**ENTERPRISE SOLAR GP INC.
ENTERPRISE SOLAR PROJECT
PROCEEDING 26322
APPLICATIONS 26322-A001 AND 26322-A002**

ENTERPRISE SOLAR GP INC. RESPONSE TO AUC ABEYANCE LETTER

RE: Project Updates as per AUC Request

Enclosed are Figure 1: Original Project Layout (100 MW) and Figure 2: Final Project Layout (65 MW) to illustrate the reduction in project size and provide the final Project layout.

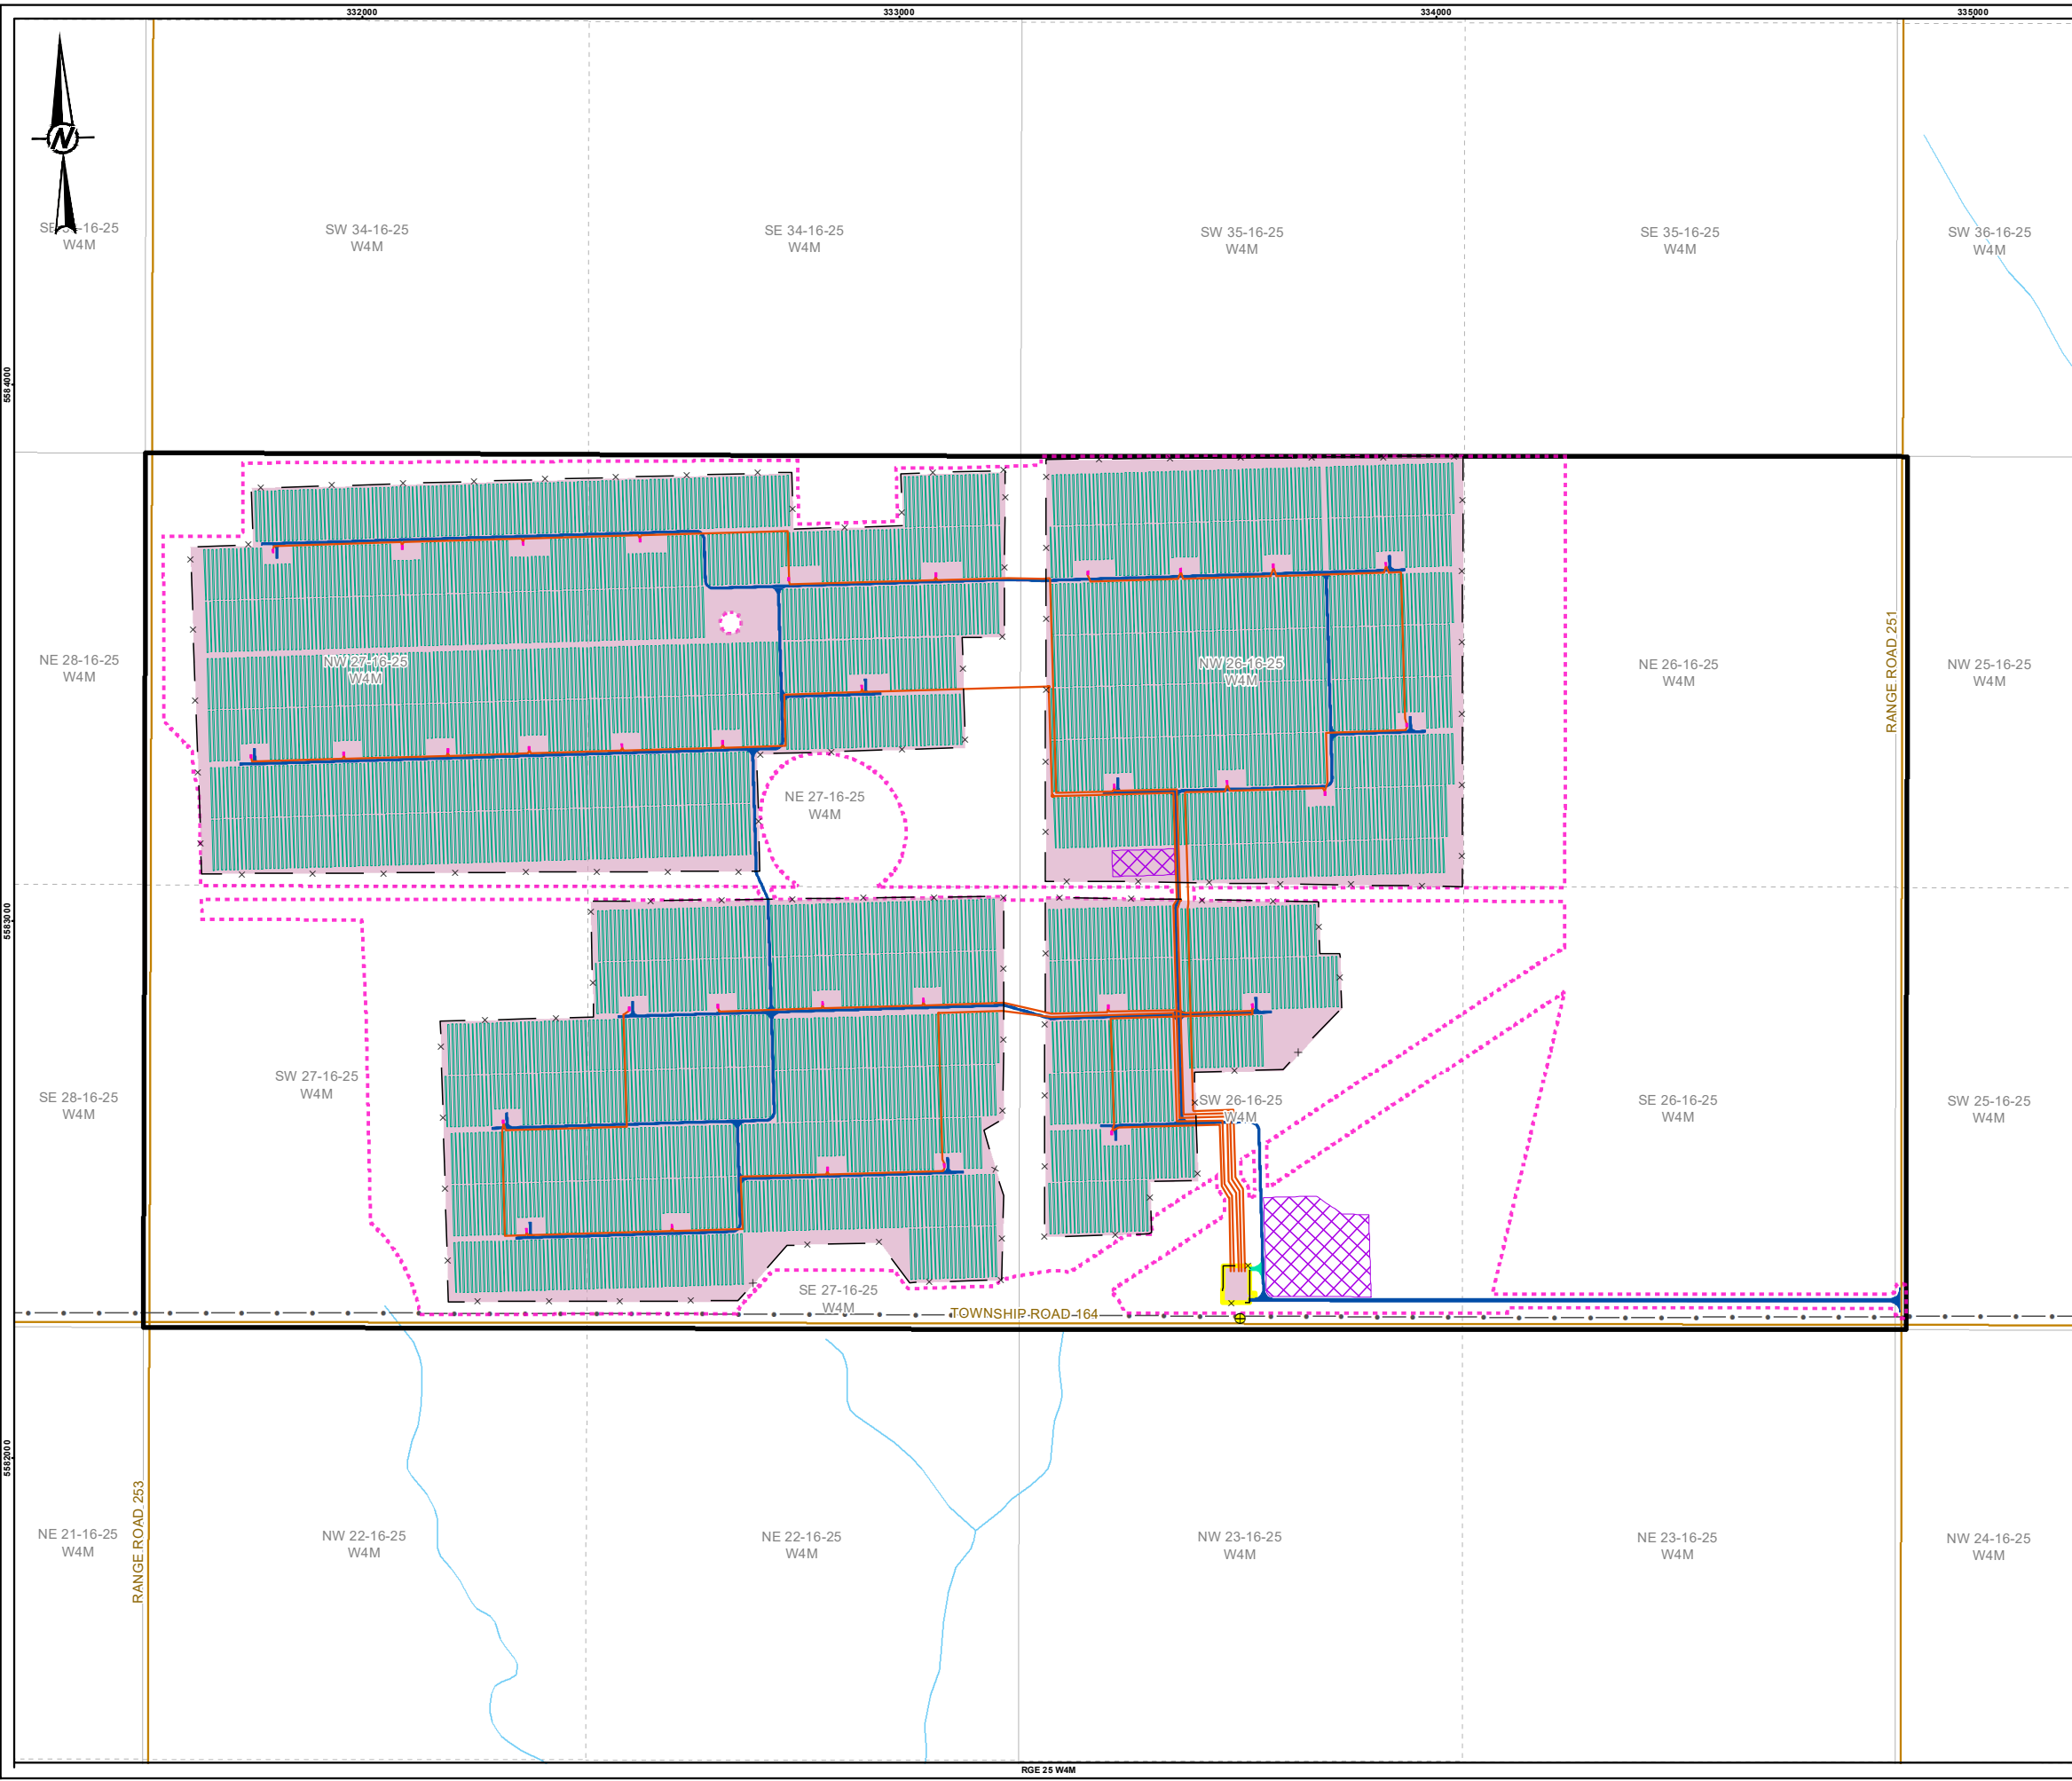
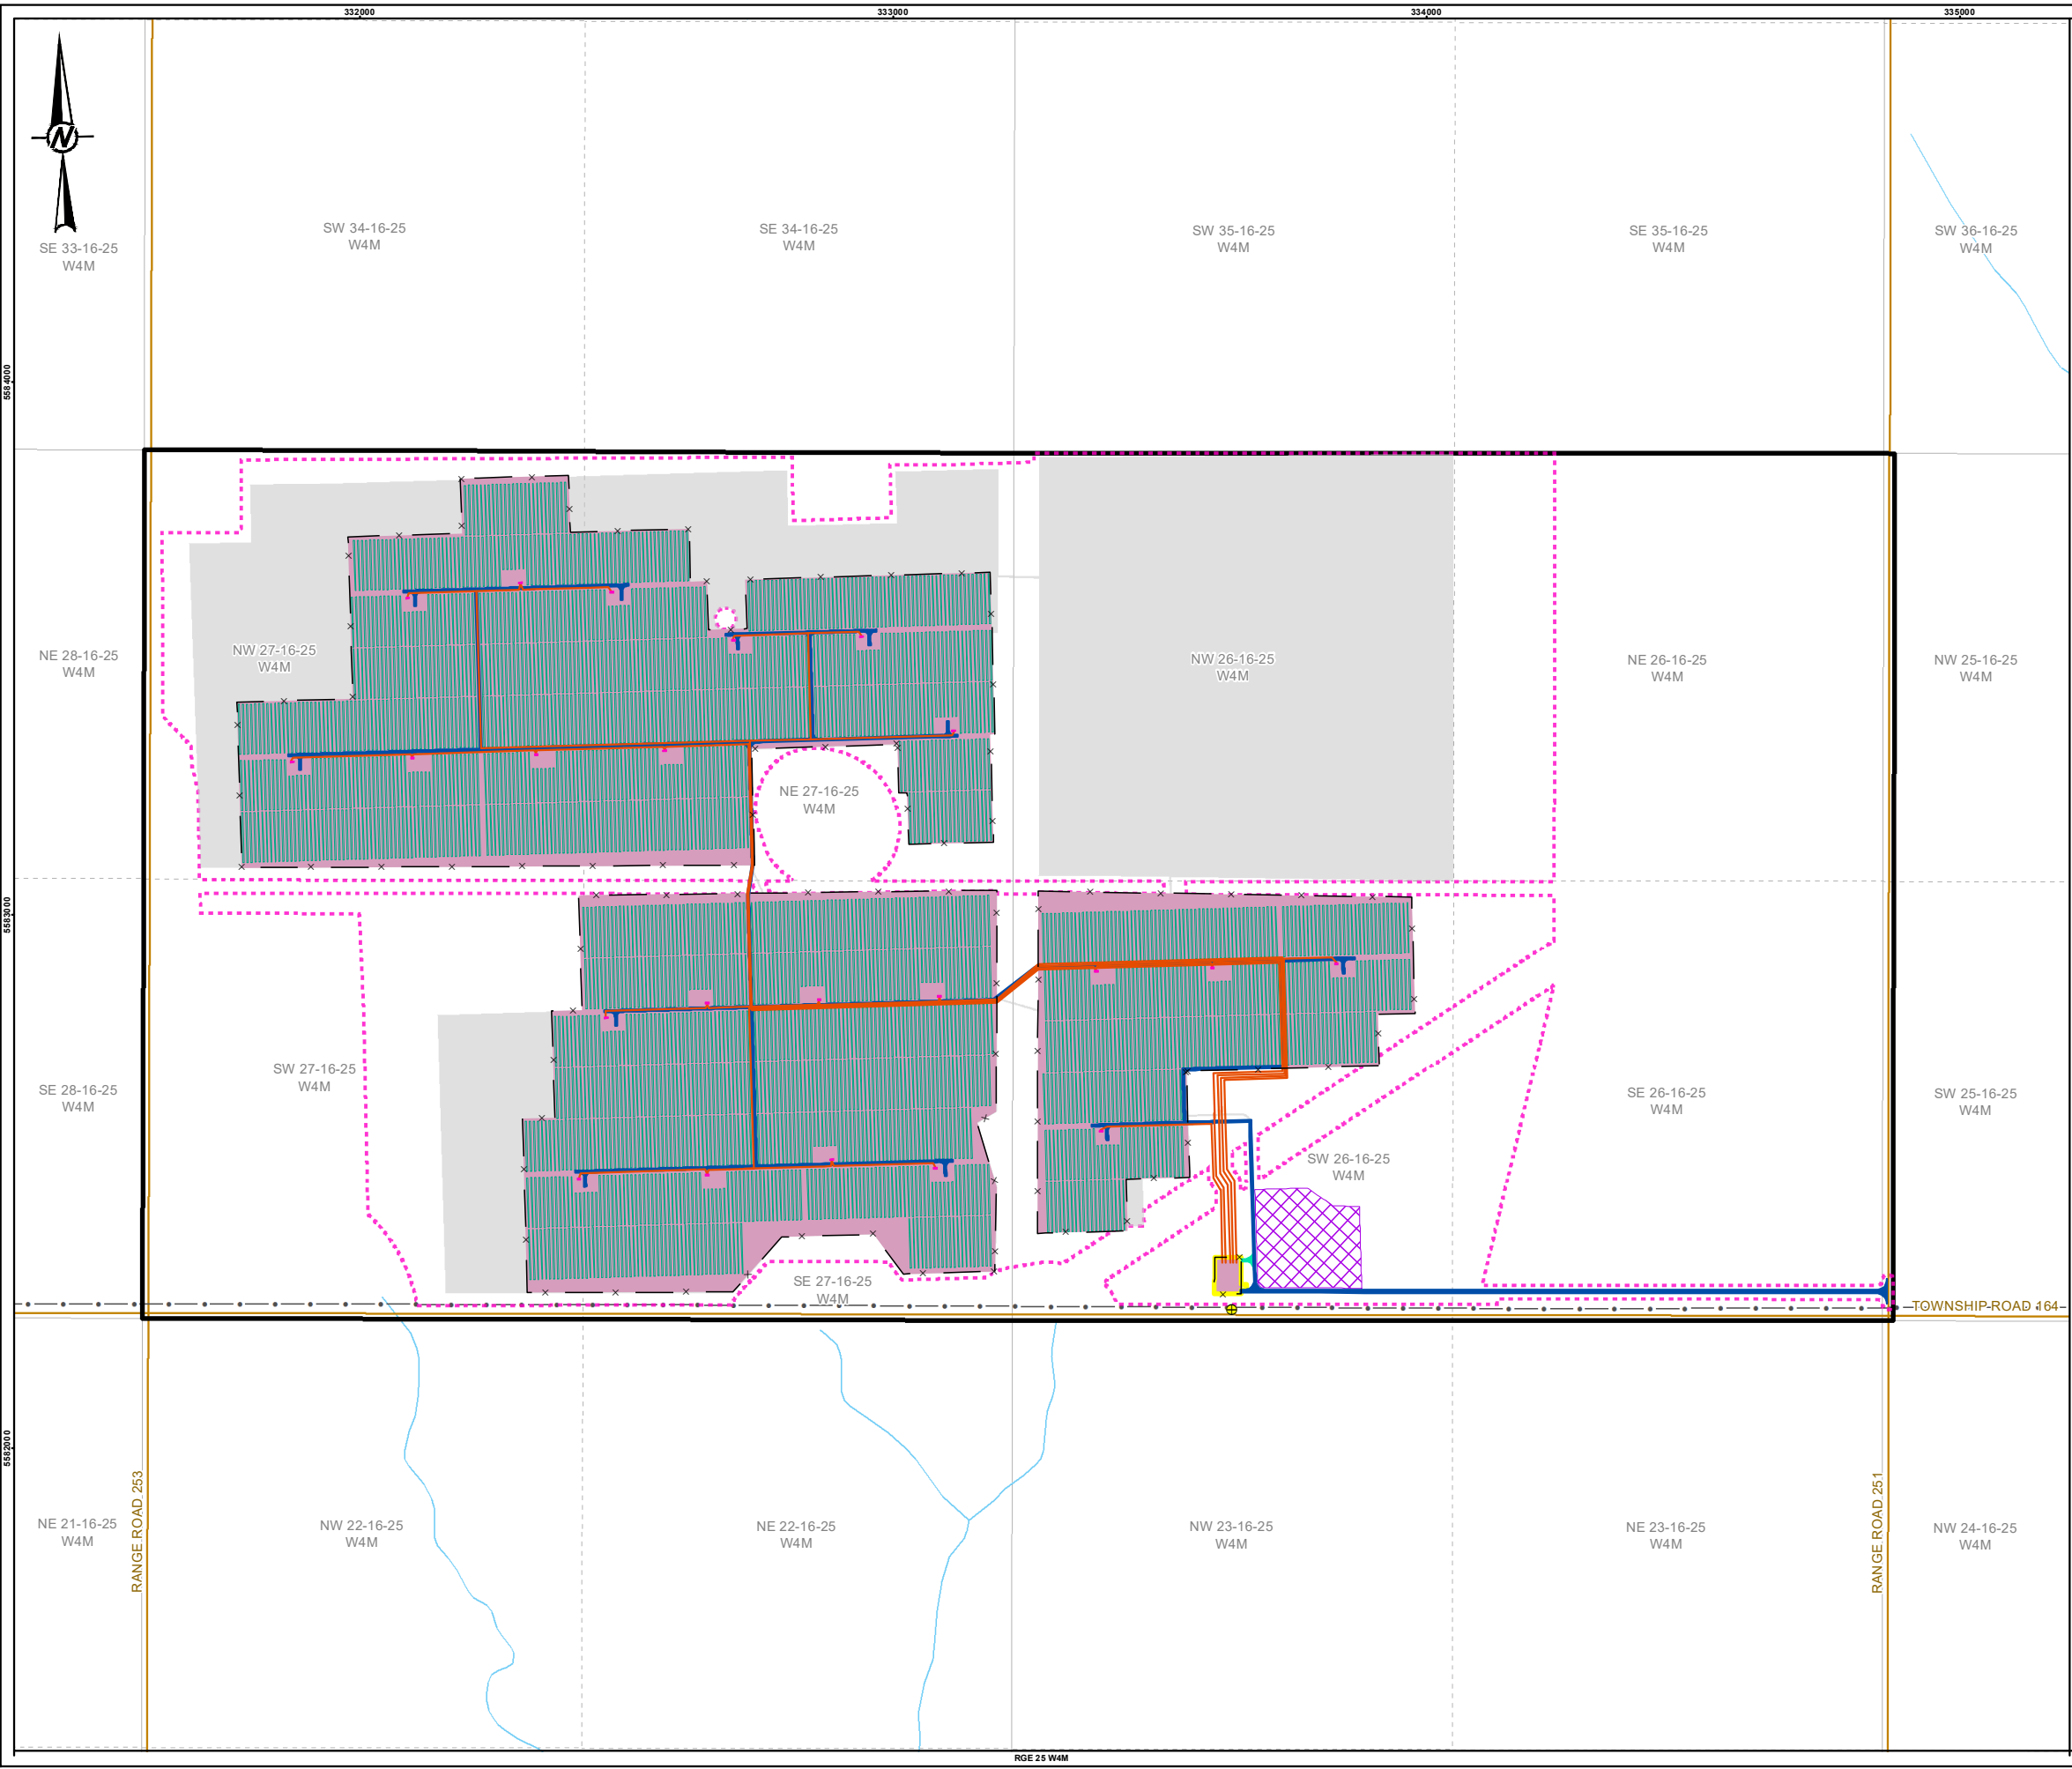
The original Project layout assessed in the Environmental Evaluation (Exhibit No. 26322-X0006) was for a 100 MW capacity solar power project. As a result of ongoing discussions and studies with the Alberta Electric Operating System (AESO), the original Project layout has been modified to accommodate a reduction to 65 MW capacity (the final Project layout). Compared to the original Project layout, the final Project layout includes a reduction in the panel array area, temporary laydown area, number of inverters, length of roads, and length of underground collector line. The substation footprint and limit of disturbance area presented in the Environmental Evaluation have been maintained.

As the footprint of the 65 MW layout is a subset of the original 100 MW Project, in which all studies and stakeholder consultation were undertaken, the Applicant believes the change associated with this reduction in nameplate capacity will result in an overall lower impact than what was originally studied, consulted on, and submitted to the Commission for approval. An explanation and the works undertaken to achieve this conclusion are presented below.

Item	100 MW Original Project	65 MW Final Project	Change in Impact
Footprint of solar facility	Approximately 620 acres on cultivated land	Approximately 450 acres within original footprint	Reduction in operational footprint of approximately 170 acres
Location of substation	SW 26, 16, 25, W4M	Same location and footprint	No change
Approximate number of 540W/545W solar modules	Approximately 242,000	Approximately 157,000	Use of approximately 85,000 less solar modules
Racking system	Single-axis tracker, with approximately 40,000 steel piles	Single-axis tracker, with approximately 26,000 steel piles	Same racking system, 14,000 less steel piles required
Number of inverters	33 SG3600UD string inverters	20-22 SG3600UD string inverters	Reduction in impact; use of 11-13 less inverters
Setback from 4 closest receptors: R01 R02 R07 R24	Approximate distances R01: 782m R02: 840m R07: 377m R24: 1025m	Approximate distances R01: 1275m R02: 1410m R07: 550m R24: 1075m	Lower Impact - Increased setbacks R01: +493m R02: +570m R07: +173m R24: +50m

Based on the information above; the Applicant is confident that the overall change from 100 MW to 65 MW has a net lower impact compared to the original application to the Commission.
